The Environmental Impact Statement (EIS) and specialist studies submitted with the development application (DA) are considered to be inadequate in a number of key areas which are listed as follows:

Revision	Date	Description	By	Review	Approved
3	27/07/2015	Final	M Hather	Strategic Planning	M Davies
			J Moore	Waste / GHG	M Davies
			I Fletcher	EfW Technology	M Davies
			M Davies	Air Quality, Odour Health Impact	M Davies
			S Hughes	Noise	M Davies
			R Gauthier	Soil and Water	M Davies

In response to a letter (the Brief) from Blacktown City Council (BCC) dated 25 March 2014 Jacobs and a subsequent Expression of Interest (EoI) from Jacobs we were engaged by Council to undertake a technical review of the Environmental Impact Statement (EIS) for The Next Generations' proposed Eastern Creek Energy from Waste (EfW) facility as per the following instructions from BCC.

**Figure 1 Two blocks – Total 4 boilers and 2 steam turbine generators.**

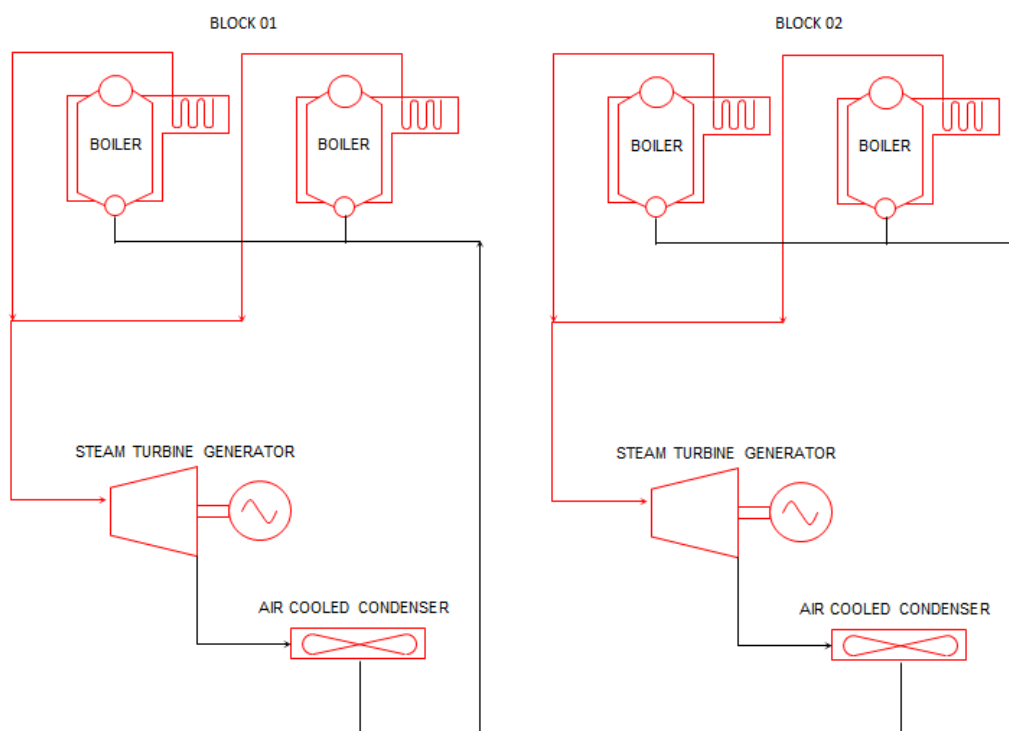
The plant is designed in two blocks each with 2 boilers feeding a single steam turbine generator (2 blocks of 2 x 1 arrangement), which totals 4 boilers or ‘4 lines’ of waste feed (refer Figure 1). It is anticipated that the blocks will be built in stages, but no indication is given of the timing.

The plant has been designed with two steam turbines, which will have higher capex and opex costs and have a moderate efficiency penalty compared to a single turbine. A single steam turbine generator has been dismissed as inappropriate for only 2 or 4 boilers operating. This isn't correct, and turbines will operate in sliding pressure mode down to half load, with the governor used for throttling the steam flow below this load. A single steam turbine is best practice for plant efficiency, and if there are reasons to deviate from best practice, then they need to be explained.

We suggest the reason for selecting two steam turbines appears to be for staging the construction of the EFW plant. This may be to mitigate against the risk fuel volumes not increasing as expected, and to avoid the expense of planning permissions at a future date for expansion.

**Figure 2: Sample Water Balance Diagram, detailing sources and quantities of waste water.**

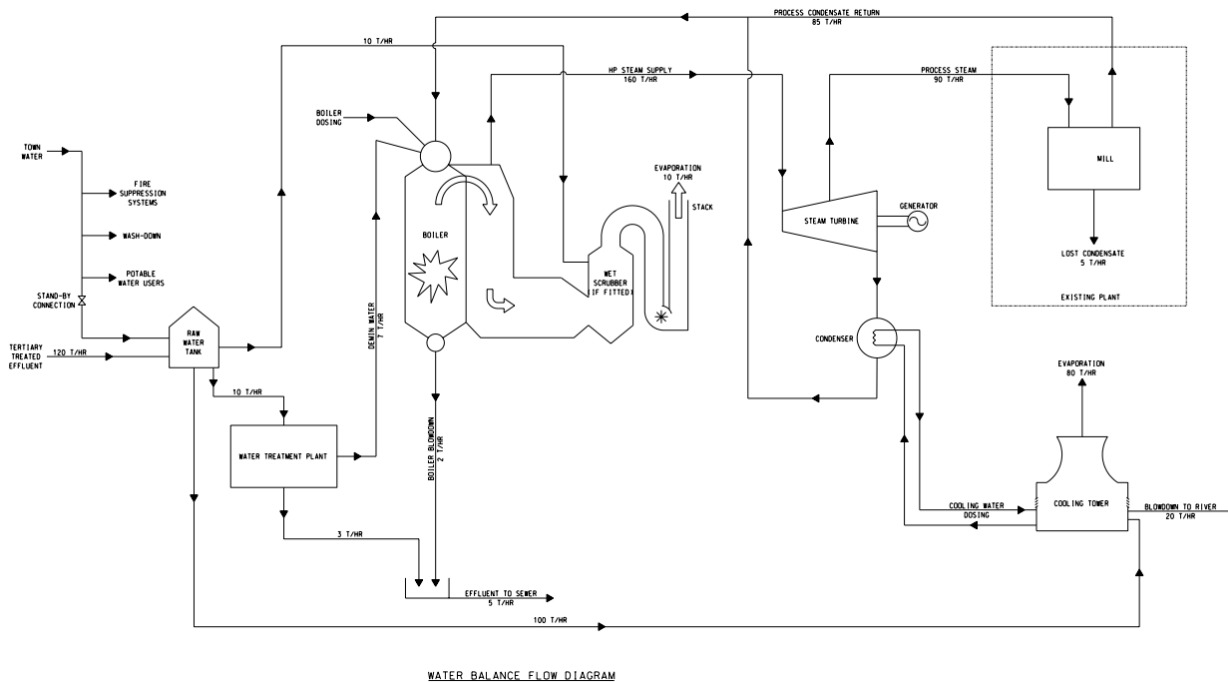
No water balance is provided, which is essential to determine how water is used and reused within the plant. The Soil and Water Report Section 7.2 and EIS Section 3.16 deals with water only at a high level for the actual power plant.

A detailed water balance must be part of the EFW concept design or by the proposed contractor. A typical diagram is provided below, which details the major flows of water throughout the process, and the sources of waste water generation. (refer **Figure 2** below)
